Applicant: Carrie Chang; Minnesota Area Realtors
Consultant: Benjamin Lucas; Solution Blue, Inc.
Project: Minnesota Area Realtors Parking Lot and Site Improvements
Location: 5750 Lincoln Drive: Edina
Rule(s): 4, 5
Reviewer(s): LLH/BCO

The project proposes parking lot and site improvements at the Minnesota Area Realtors (MAR) site located at 5750 Lincoln Drive in Edina. The 1.6-acre site is occupied by the MAR building with associated site elements and surface parking.

CIVIL SITE PLAN

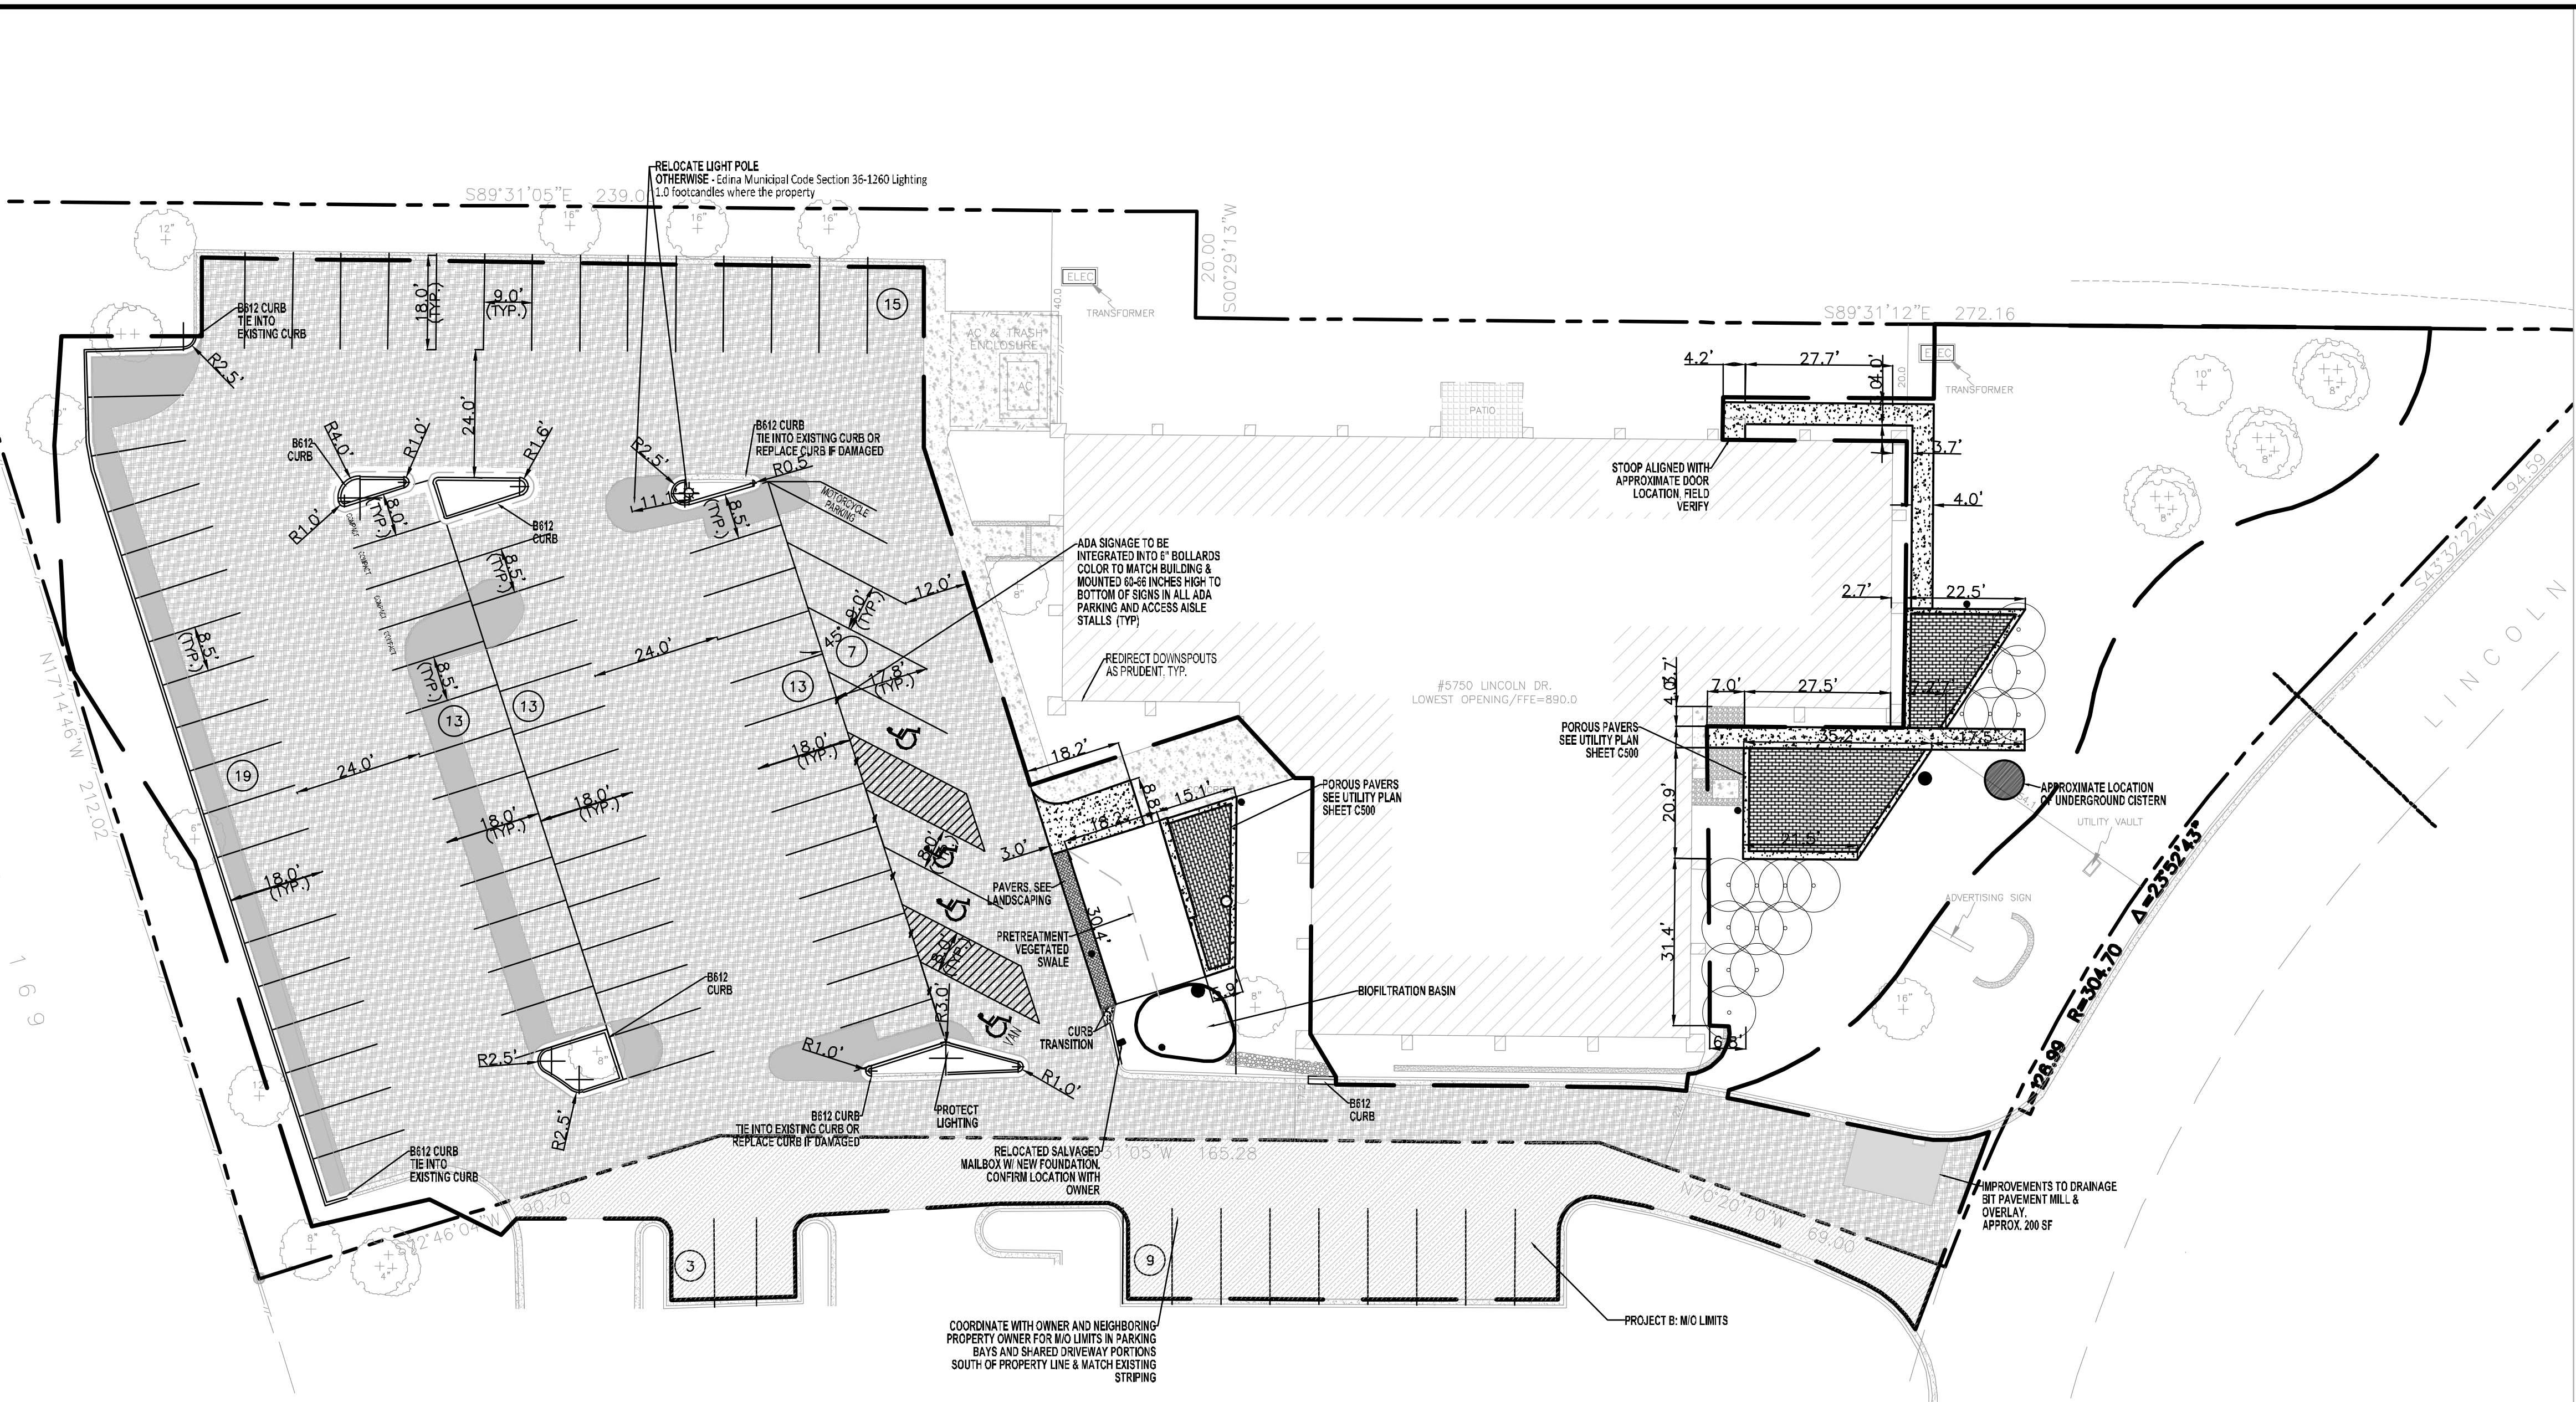
As indicated by email correspondence from the consultant dated September 8, 2021, the first floor elevation (FFE) of the building (890 M.S.L.) is the low floor and low opening elevation. The site plans must be amended to identify the first floor elevation (FFE) as the low floor and low opening elevation of the existing MAR building.
